# PERMIT

A REPAIR

SEWAGE DISPOSAL SYSTEM  
MARYLAND STATE DEPARTMENT OF HEALTH\*

ROAD 101<sup>49</sup> Maplewood Drive

INDICATE NORTH. - NAME ADJOINING ROADWAY AS BASE LINE.

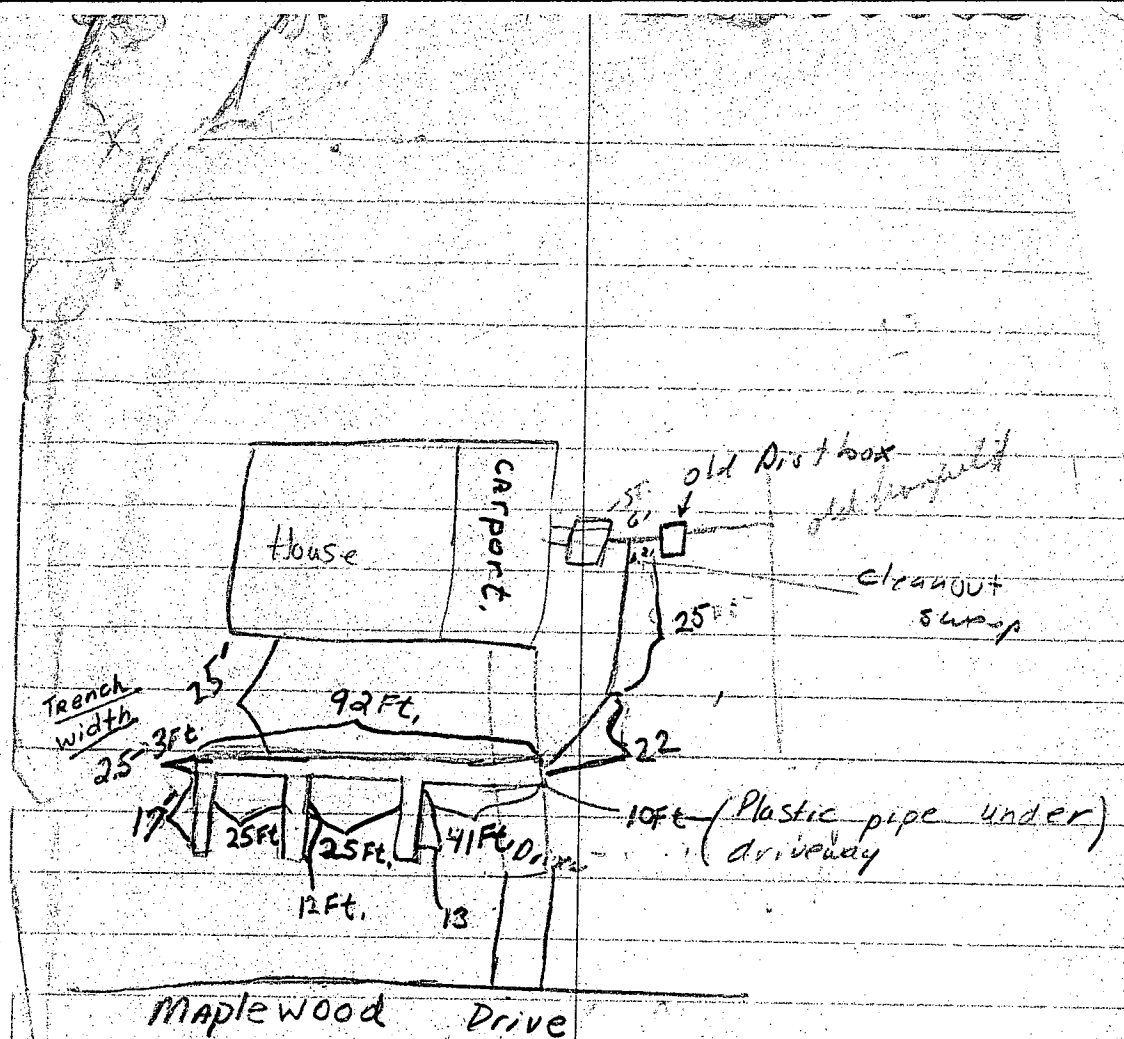
REMARKS  
 ① Saw water at 9'-9 1/2'; suggested follow F.F. recommendations  
 ② Trench 6' deep - some water at left end of trench when facing lot from road. (last 30') recommended 1' of soil be put back to stay above water table and a 10' section of cast iron under water pipe area to leave uncovered for inspection ③ also new pipe from septic tank to trench be cast iron. Old lines appear to be stopped up. Put cleanout <sup>at</sup> ~~at~~ grade near tank!

- Suggested to replace plastic pipe under driveway with iron pipe. Didn't demand since not in original specifications.

- told okay to cover system  
 3/30/78 DAVID O'Neil & M. Borgoyan.  
 OMB.
